# Architect's Supplemental Instructions

Police Department Midtown District

ASI Number 004

1/25/2018

**LOWER LEVEL PLAN**

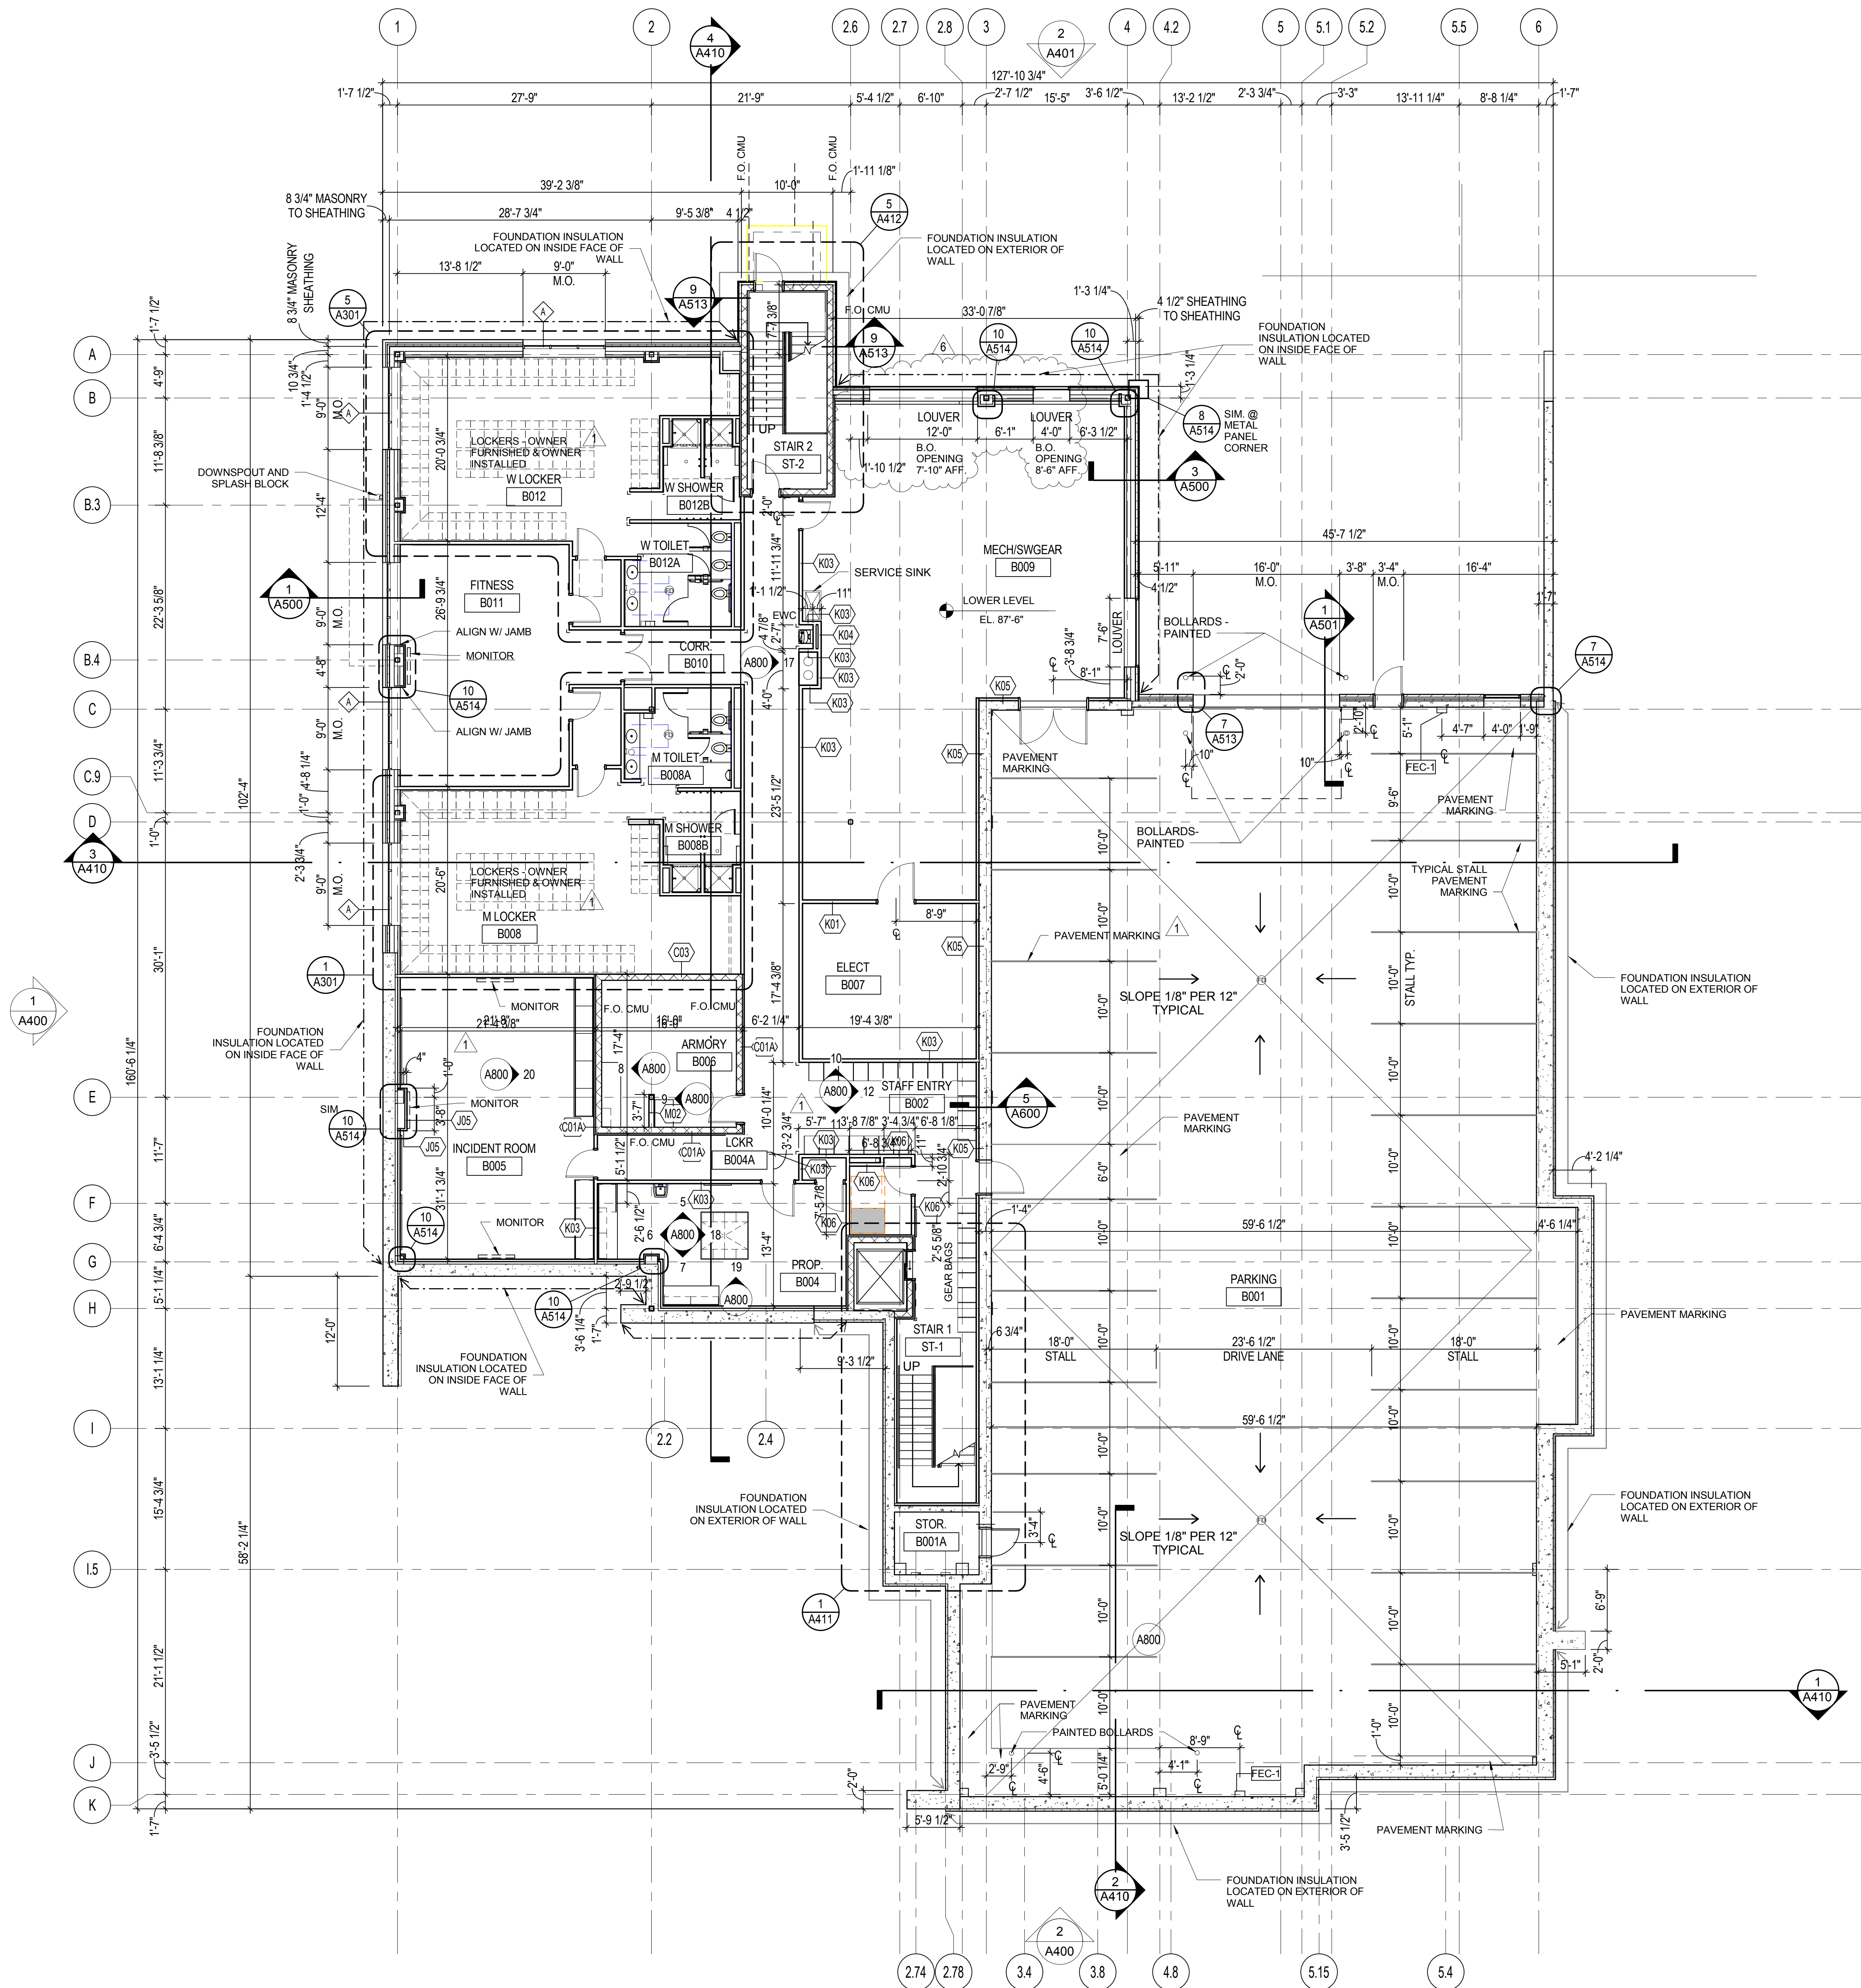
2. The attached sheet A100 is being reissued with changes to the louver opening for OAL-2 in room MECH/SWGEAR #B009 to match the louver schedule in the mechanical drawings. This change has been addressed in the cold formed metal framing shop drawings.

**FIRST FLOOR PLAN**

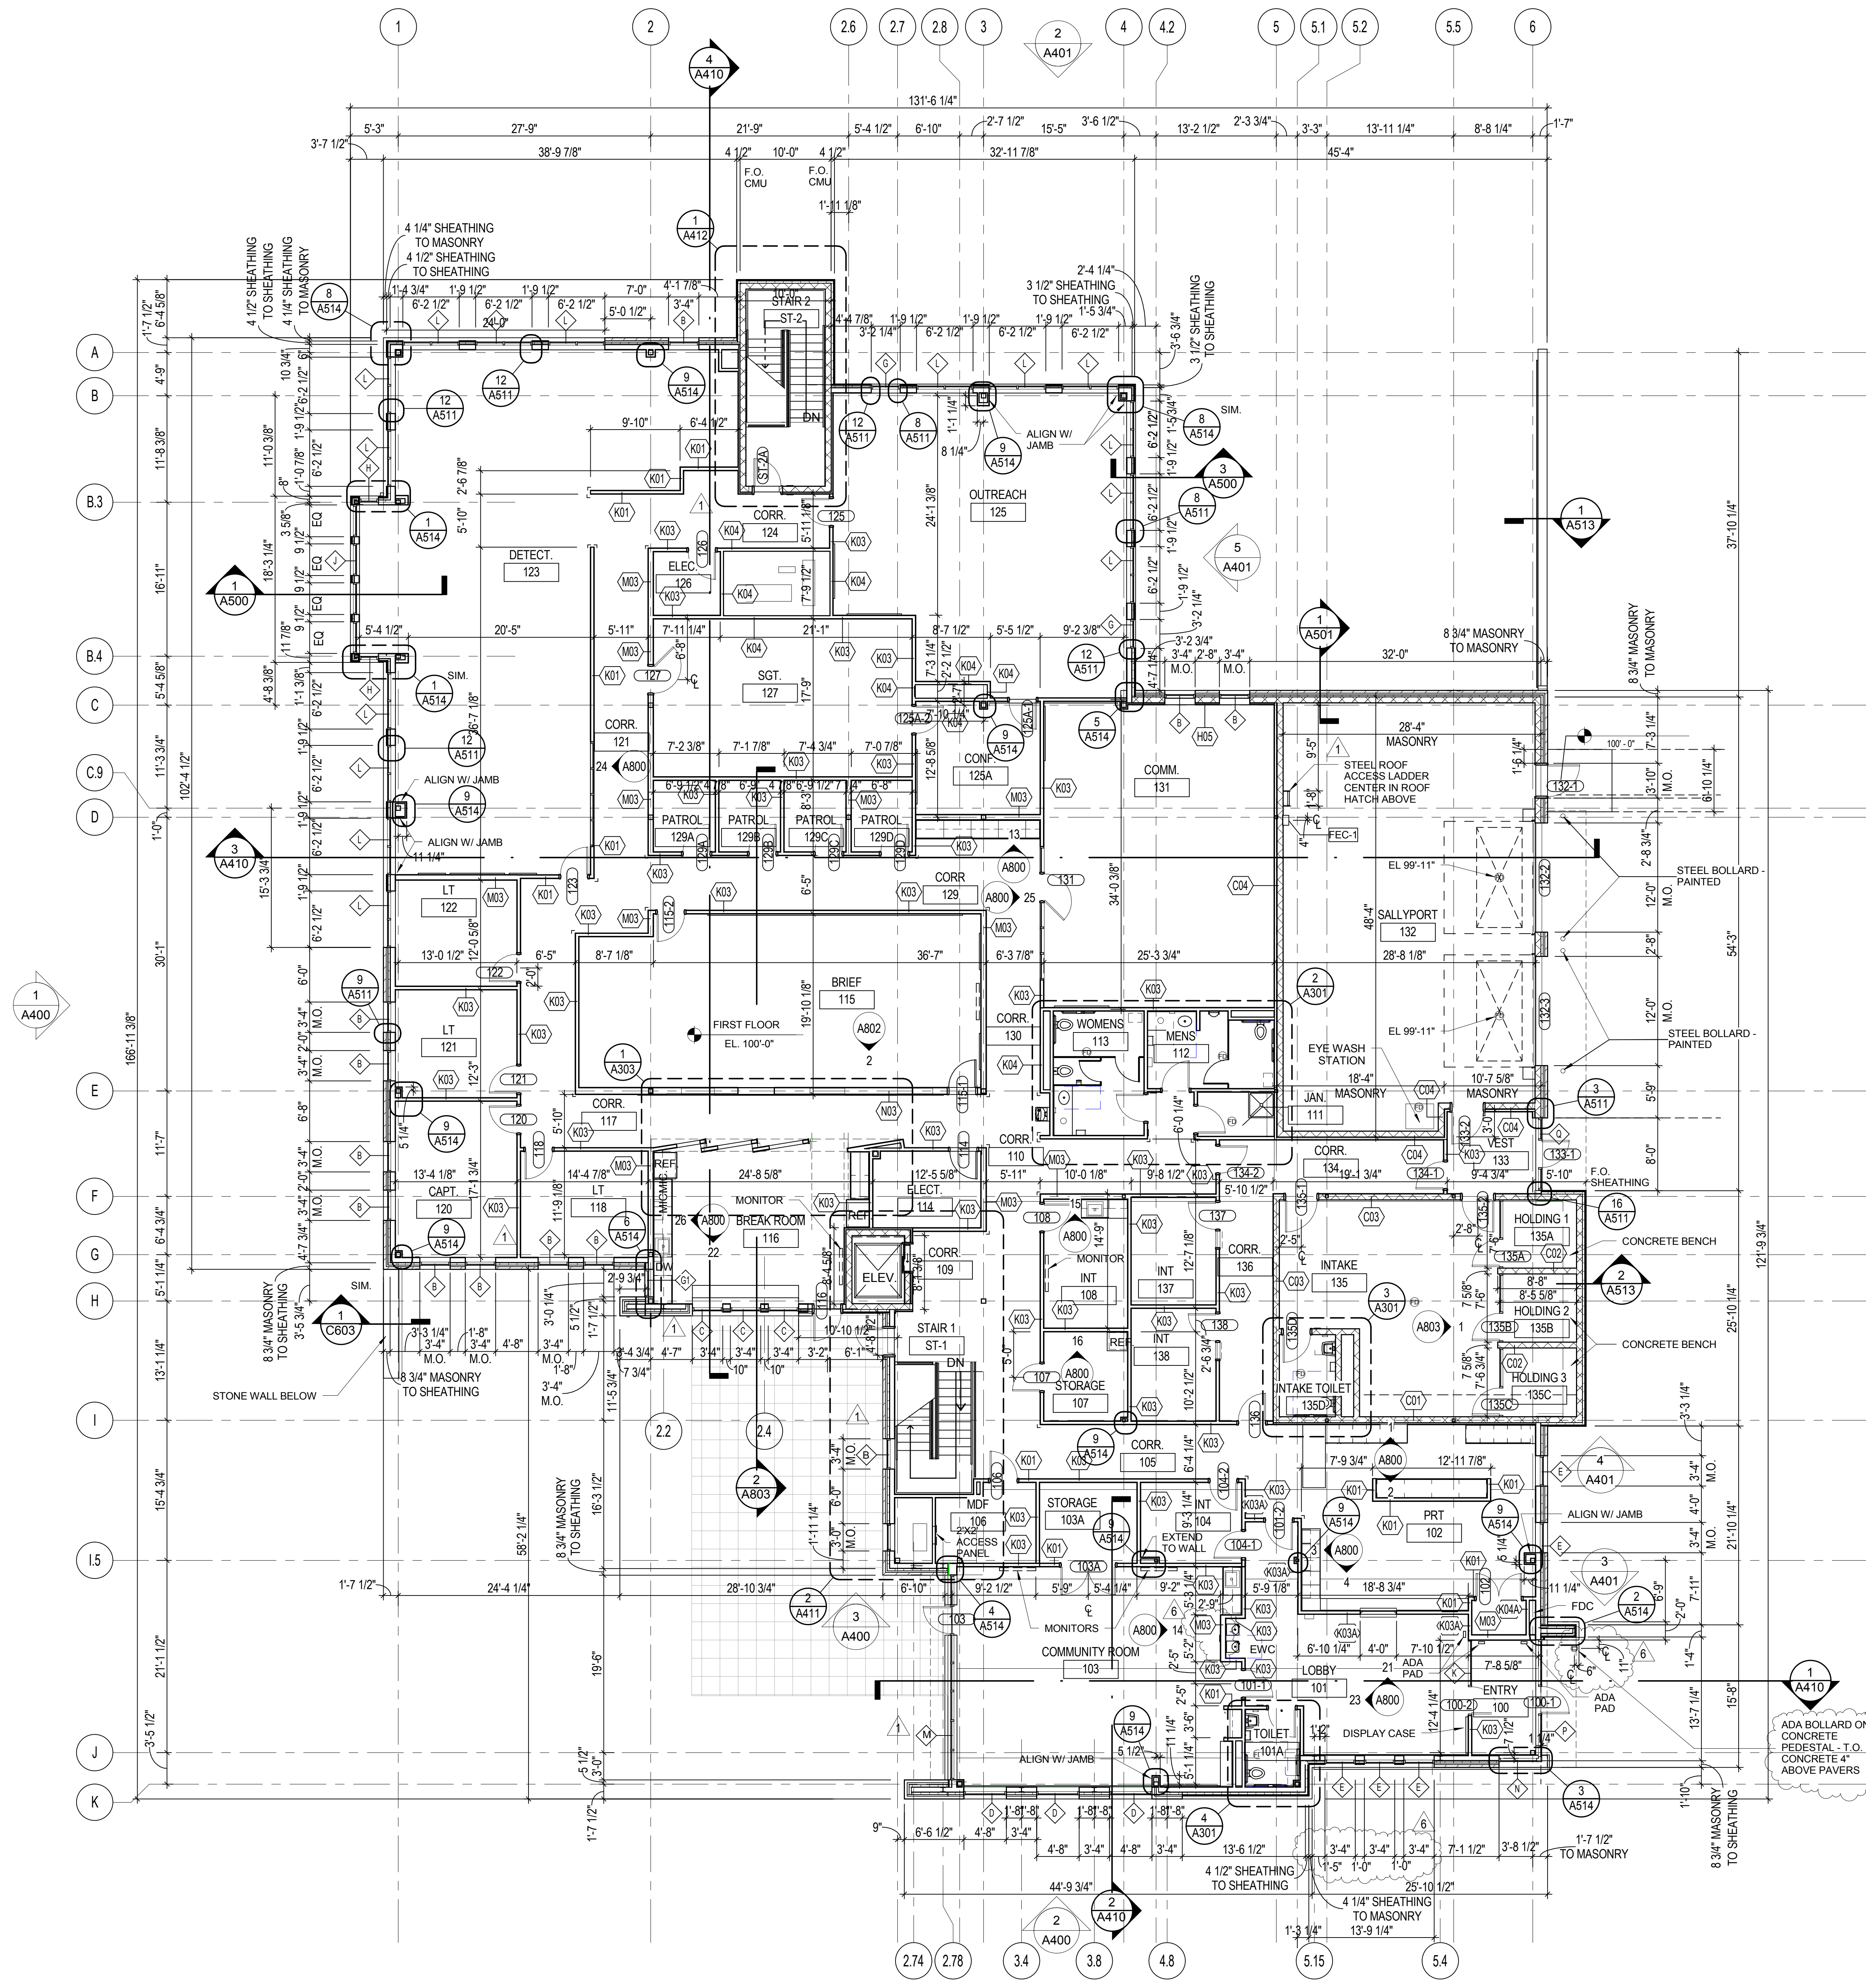
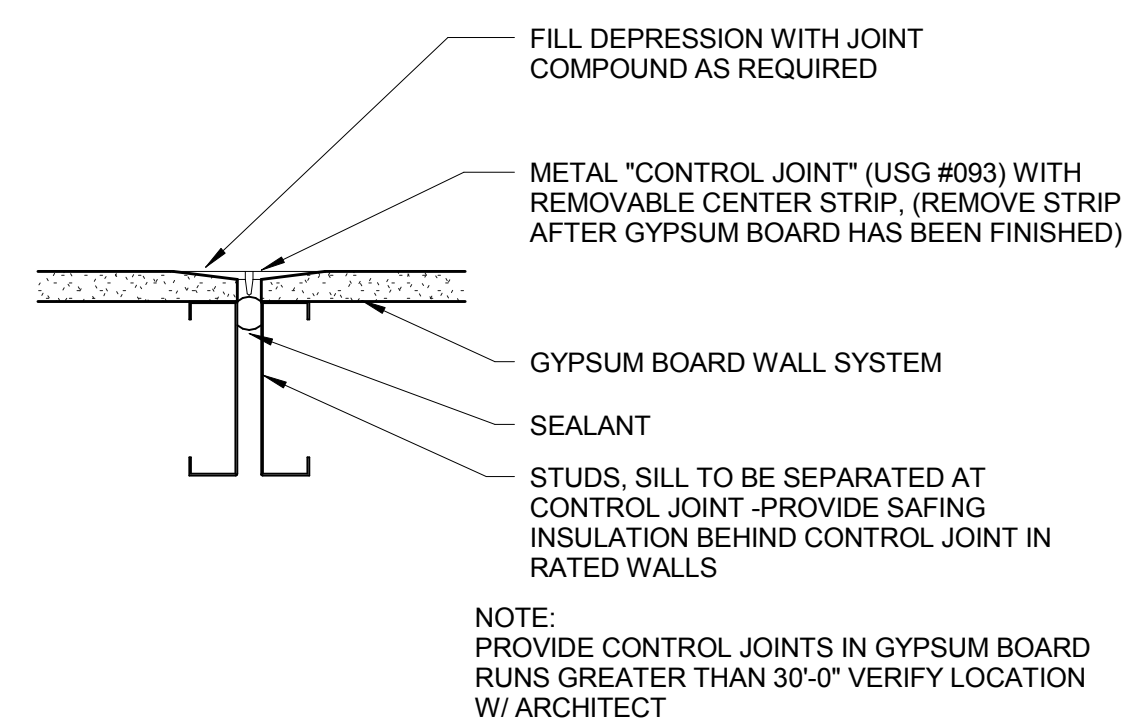
3. The attached sheet A101 has been reissued with the following changes:
  - A. Dimensional change to the window opening along column line J between column line 5.15 & 5.4 to address precast coordination issue as answered in RFI012.
  - B. Change the wall type for the wall between Community Room #103 & Lobby #101 from K03 to **M03** to allow for the roof drain to be located within as addressed in RFI 013.
  - C. At Entry #100, the Automatic door actuator on the exterior of the building has been changed from a wall mount to a bollard style. The actuator to be mounted on a concrete pedestal with top elevation 4" above the walking surface. Verify dimensions of concrete pedestal with dimensions of bollard per manufacturer.
